## **ZEE Systems, Inc.**

### ***SERVICE BULLETIN R134-05***

A. Effectivity: Bell 212 and 412 aircraft with Zee Systems, Inc. air conditioning equipment installed under STC SH3512SW.

B. Reason: To modify and upgrade the Vapor Cycle Air Conditioning system to use CFC free R-134a refrigerant.

**FIGURE 1.**

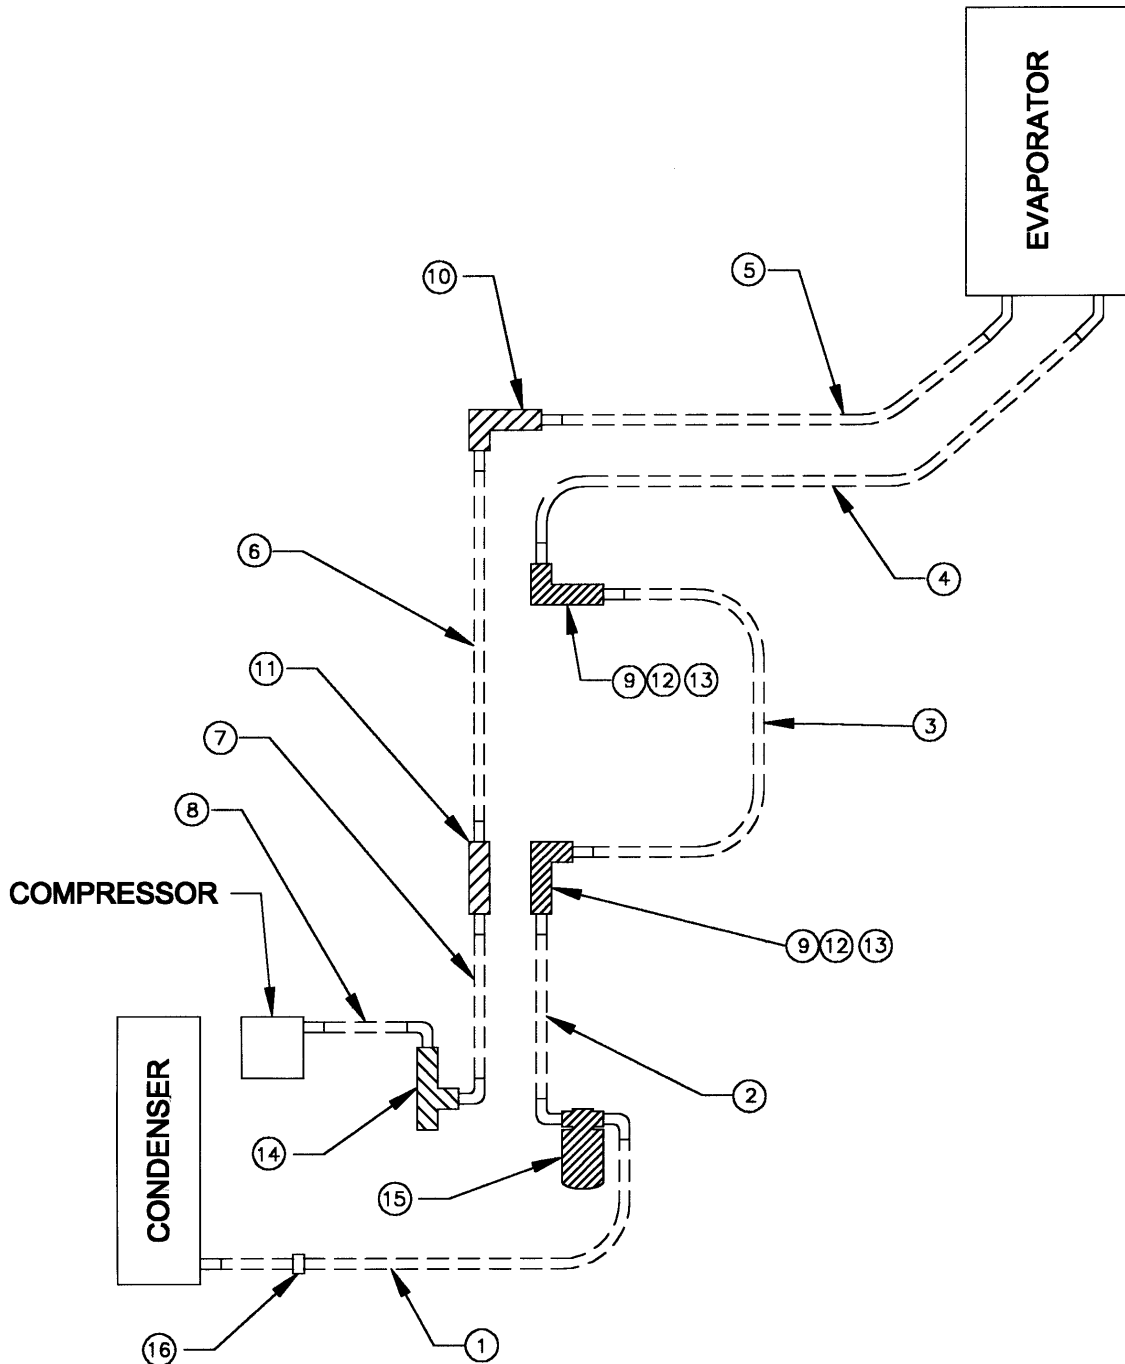
2. Install modified Evaporator Assembly, refer to SB 70-R134.
3. Modulator Valve: Install new valve, see kit KR134-05.
4. Receiver Dryer: Install new Receiver Dryer, see kit KR134-05.
5. Lines: Refer to Figure 1 for plumbing routing.
6. Reconnect system to its normal configuration.
7. Tighten all connections, do not over tighten. Take care not to damage the O-Ring at each fitting.

Parts and materials required are listed below. Quantities are for one aircraft. The (#) corresponds to item in Figure 1.

QTY	FIG.1	Part Number	Description	Old Part Number - Disposition
1ea	(1)	Z2016AC256	Hose Assembly	Z1014000V230, Discard
1ea	(2)	Z2016AC126	Hose Assembly	Z1014000V100, Discard.
1ea	(3)	Z2016AA600	Hose Assembly	Z1014000A580, Discard.
1ea	(4)	Z2016090BC563	Hose Assembly	Z1014090W540, Discard.
1ea	(5)	Z20110090BC490	Hose Assembly	Z10110080W450, Discard.
1ea	(6)	Z20110AA634	Hose Assembly	Z10110000A600, Discard.
1ea	(7)	Z20110AC070	Hose Assembly	Z10110000V050, Discard.
1ea	(8)	Z20110AC074	Hose Assembly	Z10110000V054, Discard.
2ea	(9)	DS290B-6	Fitting, 90° Bulkhead	AN833-4D, Discard.
1ea	(10)	DS290B-10	Fitting, 90° Bulkhead	AN833-10D, Discard.
1ea	(11)	DS200B-10	Fitting, ST. Bulkhead	AN932-10D, Discard.
2ea	(12)	AN924-8D	Nut	AN924-4D, Discard.
2ea	(13)	AN901-8D	Washer	AN901-4D, Discard.
1ea	(14)	SZ41-016-6C	Modulator Valve	SZ41-016-1 - Discard.
1ea	(15)	7-8159A	Receiver Dryer	7-8159 - Discard or, 249031-30 - Discard.

QTY	FIG.1	Part Number	Description	Old Part Number - Disposition
1ea	(1)	Z2026AC256	Hose Assembly	Z1014000V230, Discard
1ea	(2)	Z2026AC126	Hose Assembly	Z1014000V100, Discard.
1ea	(3)	Z2026AA600	Hose Assembly	Z1014000A580, Discard.
1ea	(4)	Z2026090BC563	Hose Assembly	Z1014090W540, Discard.
1ea	(5)	Z20210090BC490	Hose Assembly	Z10110080W450, Discard.
1ea	(6)	Z20210AA634	Hose Assembly	Z10110000A600, Discard.
1ea	(7)	Z20210AC070	Hose Assembly	Z10110000V050, Discard.
1ea	(8)	Z20210AC074	Hose Assembly	Z10110000V054, Discard.
2ea	(9)	DS290B-6	Fitting, 90° Bulkhead	AN833-4D, Discard.
1ea	(10)	DS290B-10	Fitting, 90° Bulkhead	AN833-10D, Discard.
1ea	(11)	DS200B-10	Fitting, ST. Bulkhead	AN932-10D, Discard.
2ea	(12)	AN924-8D	Nut	AN924-4D, Discard.
2ea	(13)	AN901-8D	Washer	AN901-4D, Discard.
1ea	(14)	SZ41-016-6C	Modulator Valve	SZ41-016-1 - Discard.
1ea	(15)	7-8159A	Receiver Dryer	7-8159 - Discard or, 249031-30 - Discard.
